I-595 (SR-862)
PROJECT DEVELOPMENT & ENVIRONMENT STUDY

FM No. 409354-1-22-01
FAP No. 5951 539 I
From the I-75 Interchange
To the I-95 Interchange
Broward County, Florida

**Subject: Value Engineering / Design Review Documentation Report
I-595 PD&E Study
FM # 409354-1-22-01**

Value Engineering Study Report

RECOMMENDATION NO. 1A: Elevated Reversible Direct Connect to the West End

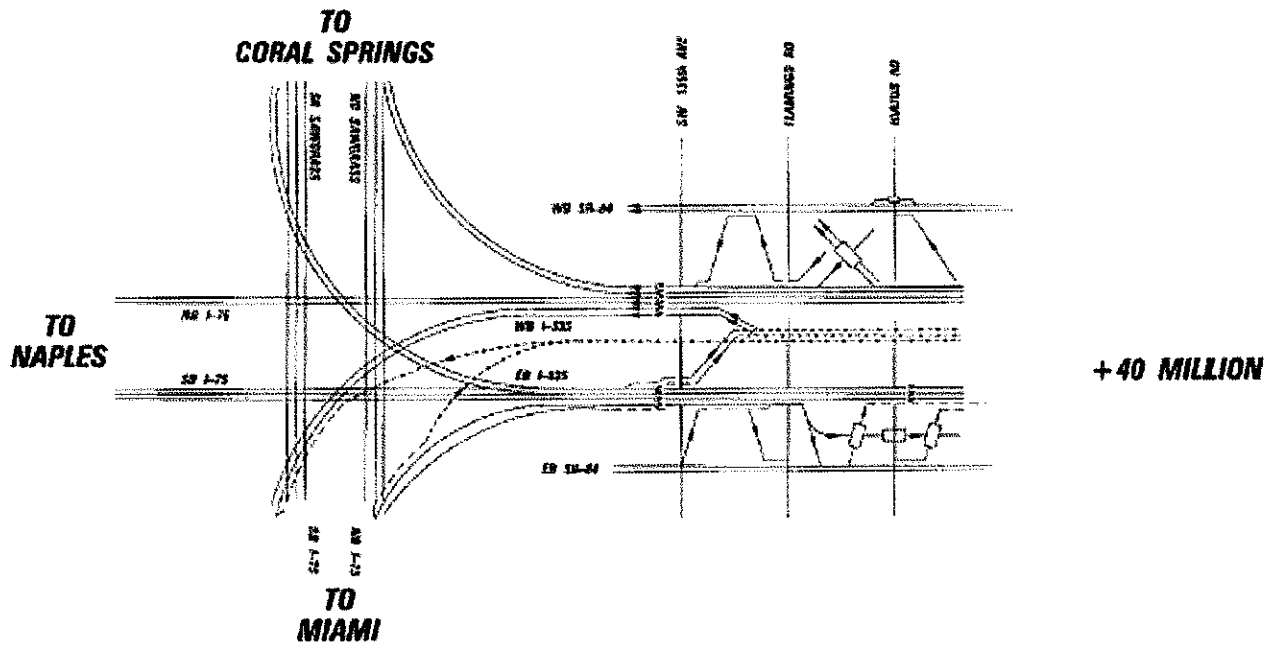
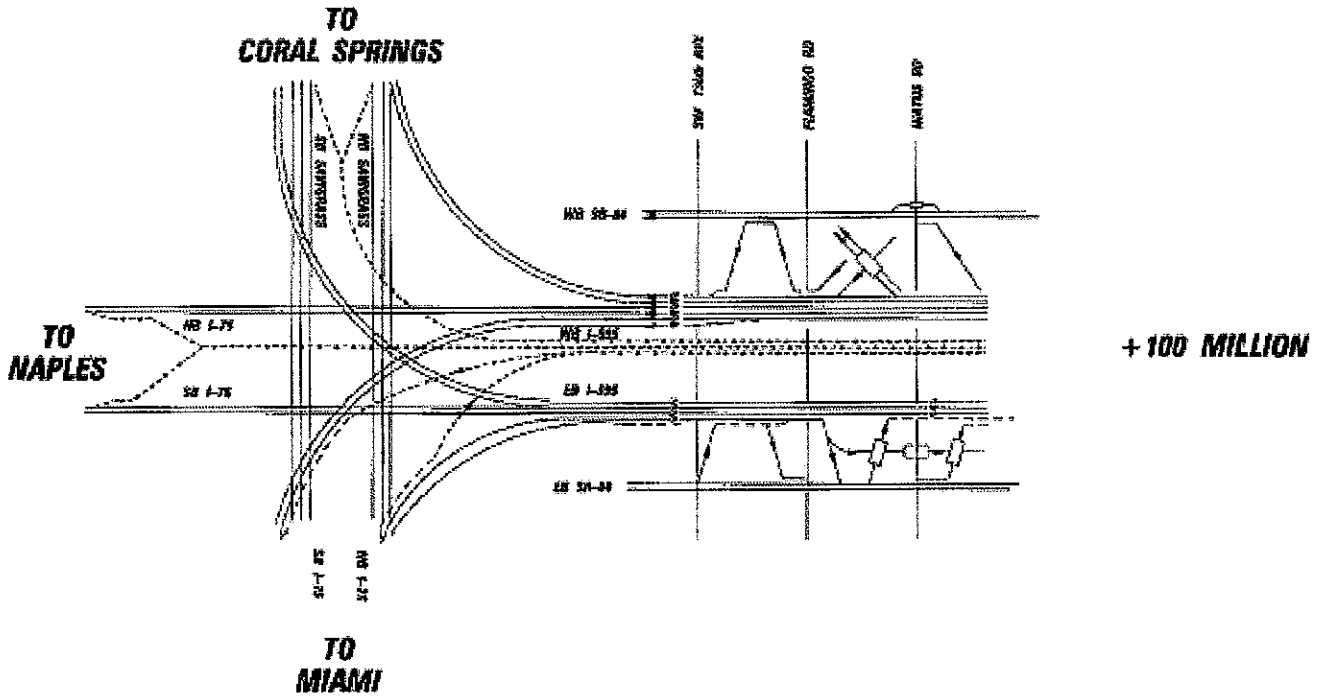
Advantages:

- Less Bridge cost
- Eliminates structure length going to Sawgrass and provide ramp (partial structure) to heaviest movements WB/SB or SB/EB on I-75 I/C and I-595
- Noise impacts reduced
- Visual impacts reduced
- Allows for future direct connects as traffic demand increases

Disadvantages:

- Needs straddle bent support
- Redesign needed

Response: Ramp spacing prohibits the I-75 NB from Miami to the I-595 eastbound reversible lanes as recommended by the VE team. An option of connecting into the I-75 median south of I-595 was explored and was presented to the VE team at Value Engineering Session No. 4. A later recommendation (Value Engineering Session No. 4, Recommendation No. 5 has been incorporated into the design).

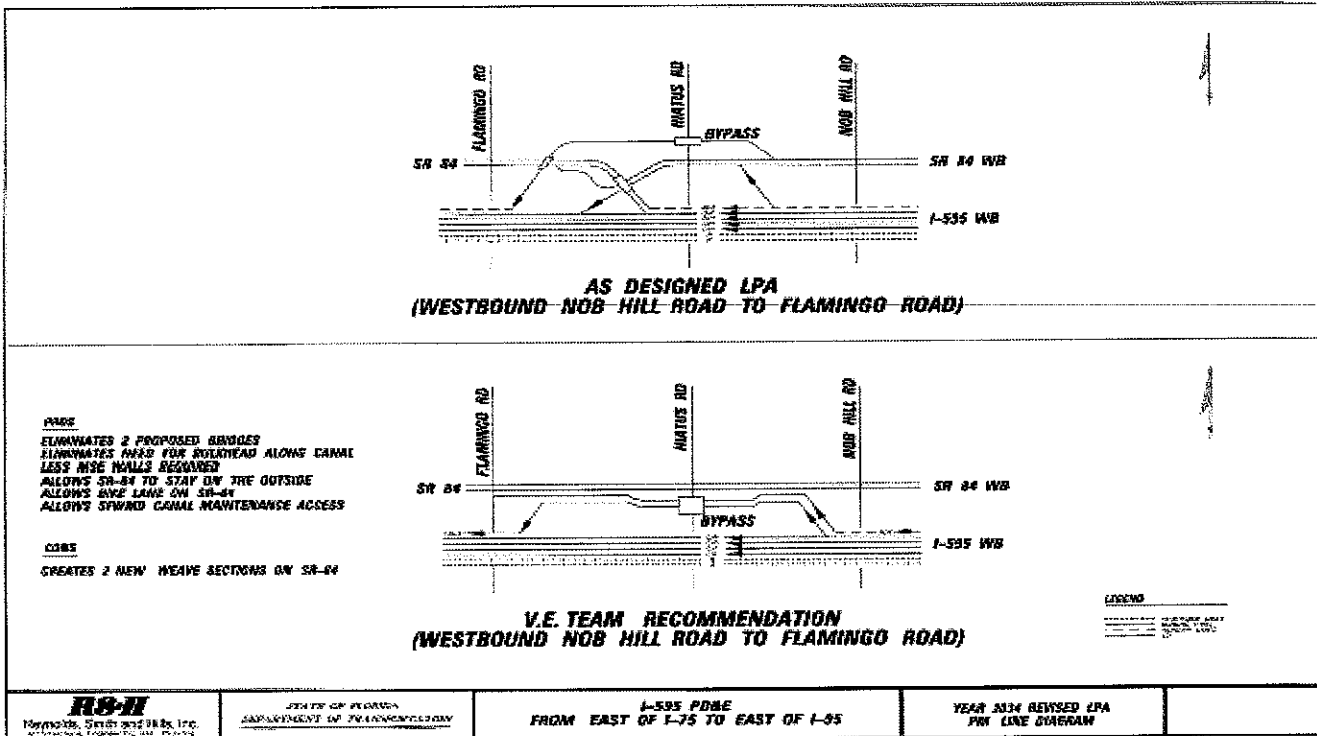
Proposed Concept: VE team proposes improvements to the WB Braided ramp system at Hiatus and Flamingo Roads. These improvements propose to maintain SR 84 with accompanying bike lane along the canal. The VE team also reviewed the braided ramps at Nob Hill Road and concluded that the canal encroachment has been maximized and could not re-align SR 84 to the north to allow bike lanes to stay on the outside adjacent to the curb. If the roadway typical section Option 2 is chosen for the project, these braided ramps may be further improved.

- Eliminates two braided bridges at Hiatus/Flamingo Roads
- Reduces need for bulkhead on canal
- Simpler design and provides operational improvement
- Allows for bike lanes on SR 83 in this area (keeps SR-84/bike lanes adjacent to canal)

Response: The improvements to the braided ramp system at Nob Hill Road and Flamingo are incorporated into all alternatives being developed in order to allow SR-84 and the bike lanes along SR-84 to remain on the outside of the braided ramps. The improvements also diminish impacts to the adjacent SFWMD canal.

RECOMMENDATION NO. 3: Transit Connections to the Median

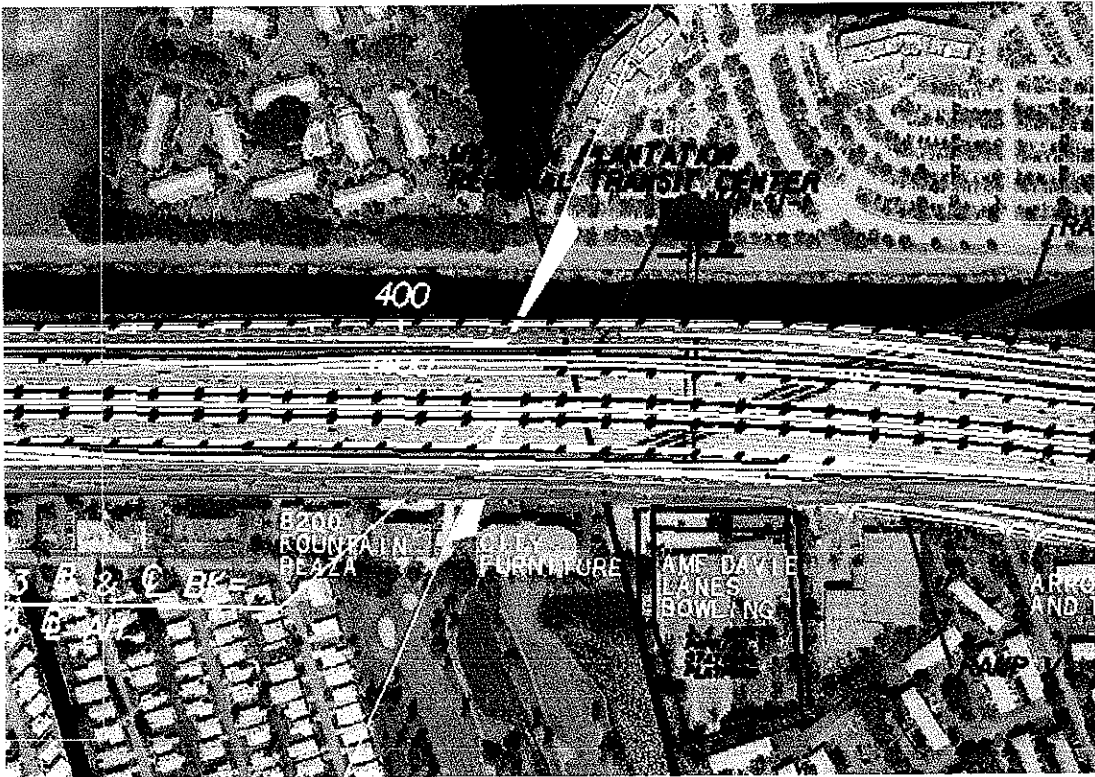
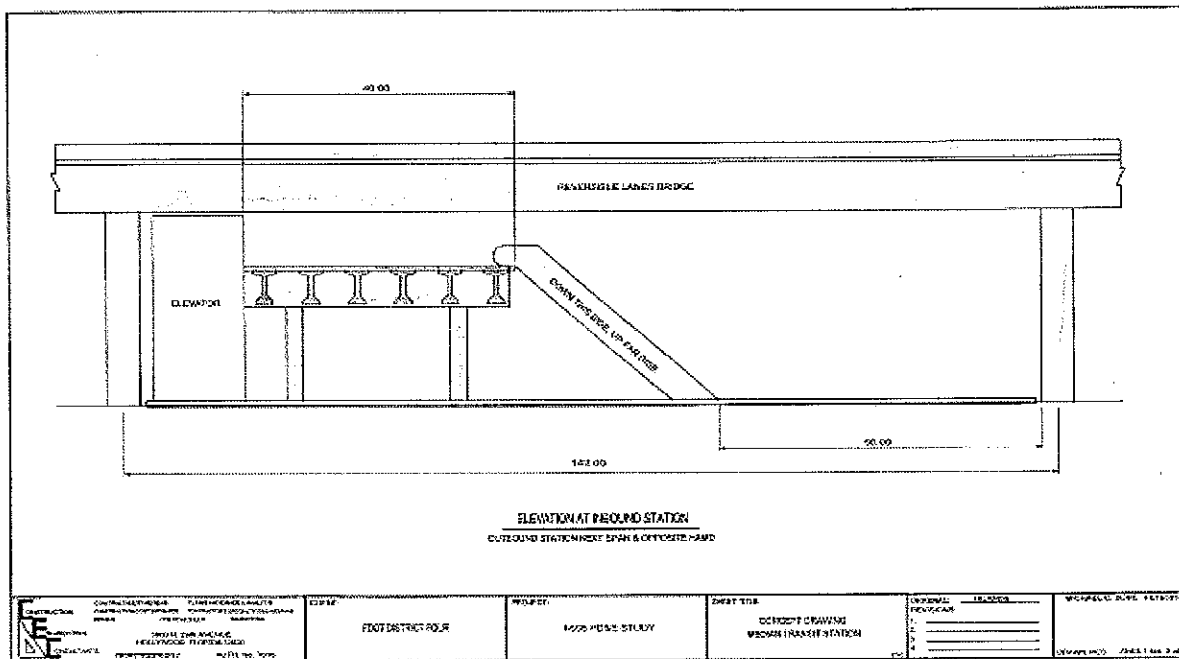
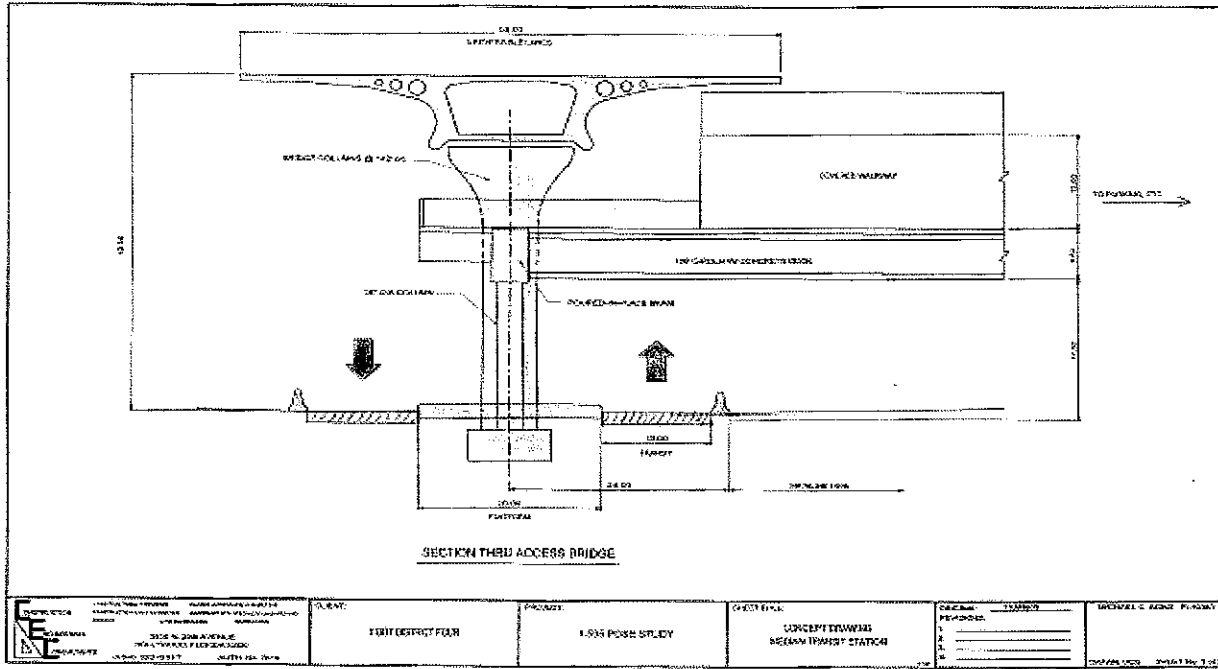
Advantages:

- Validates median transit concept by showing median transit concept geometry that can be accommodated

Disadvantages:

- Raises the reversible lane at the connection points

Response: The design team worked in conjunction with the CBEWTAA design team to accommodate transit in the median and the entrance and egress points in/out of the median in what will later be known as Alternative 2A. Transit station locations and designs of those stations (in median or on outside of I-595) are still yet to be determined.
